**ALASKA POWER AUTHORITY
EXTERNAL REVIEW PANEL
SUSITNA HYDROELECTRIC PROJECT**

APRIL, 1982

EXTERNAL REVIEW PANEL

REPORT NO. 1

FIGURE I

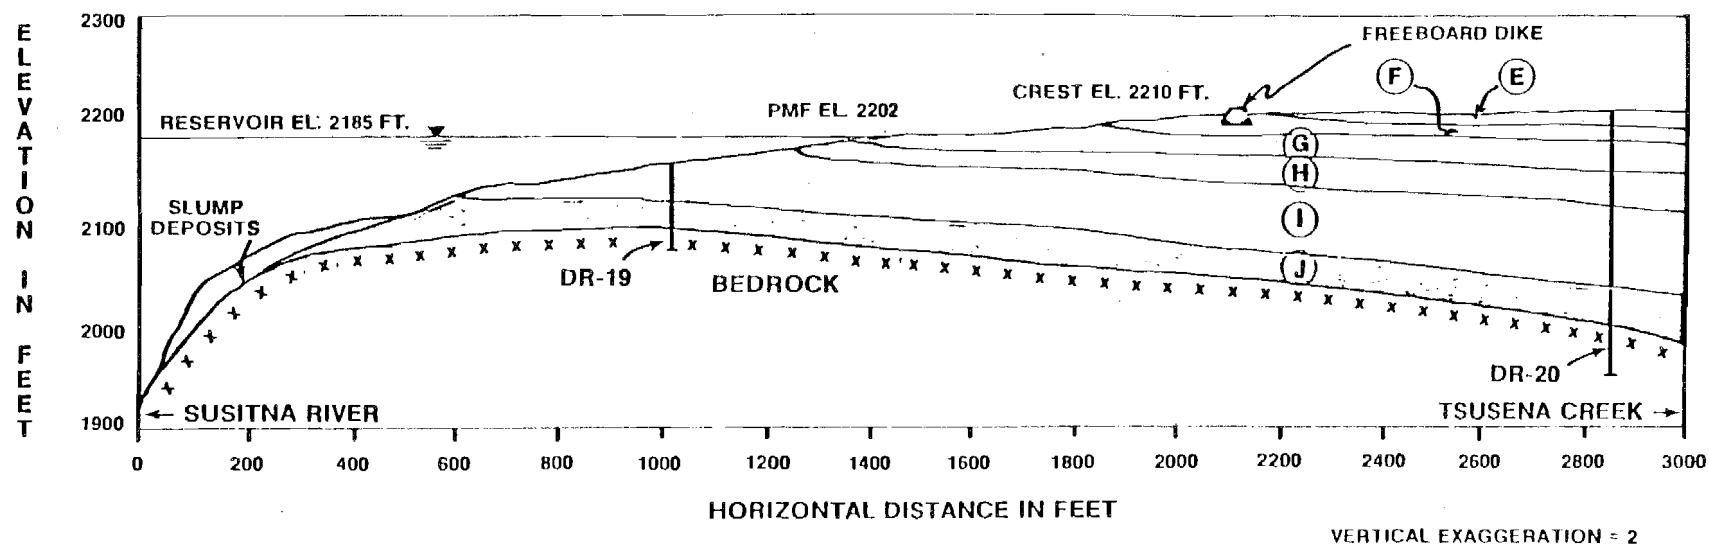
Recently, the possibility of liquefaction of the uppermost layers of the buried channel fillings has been raised. If these materials liquified, and if large volumes of these materials could move under the gentle slopes shown in attached section W-16 of Figure 6.34, Task 5 Report; then it would be hypothetically possible to breach the reservoir. Recent stratigraphy has been developed for the buried channel which is shown in attached Figure 1. As shown in Fig. 1, the lower unit K is the buried alluvium, unit J is a preloaded till, unit J1 is an interglacial alluvium, unit I is a preloaded till, unit H is an alluvium, unit G is a waterlain till or lucustrine deposit, and units A,B,C,D,E and F are more recent outwash deposits. It is highly unlikely that liquefaction could be a problem from the top of unit I downward as shown in the cross section given in Figure 2.

The alluvium in stratum H will be saturated by the reservoir, however, and more information is needed to conclude whether liquefaction is or is not a problem in stratum H. Stratum H is buried beneath the water laid till unit G, which indicates it was saturated under the water levels which produced unit G and was probably subjected to earthquakes during that time period. Further development of the pleistocene geology may clarify this point. The strata above unit G are outwash materials and more information is required on density, gradations, and blow counts in order to make definite comments
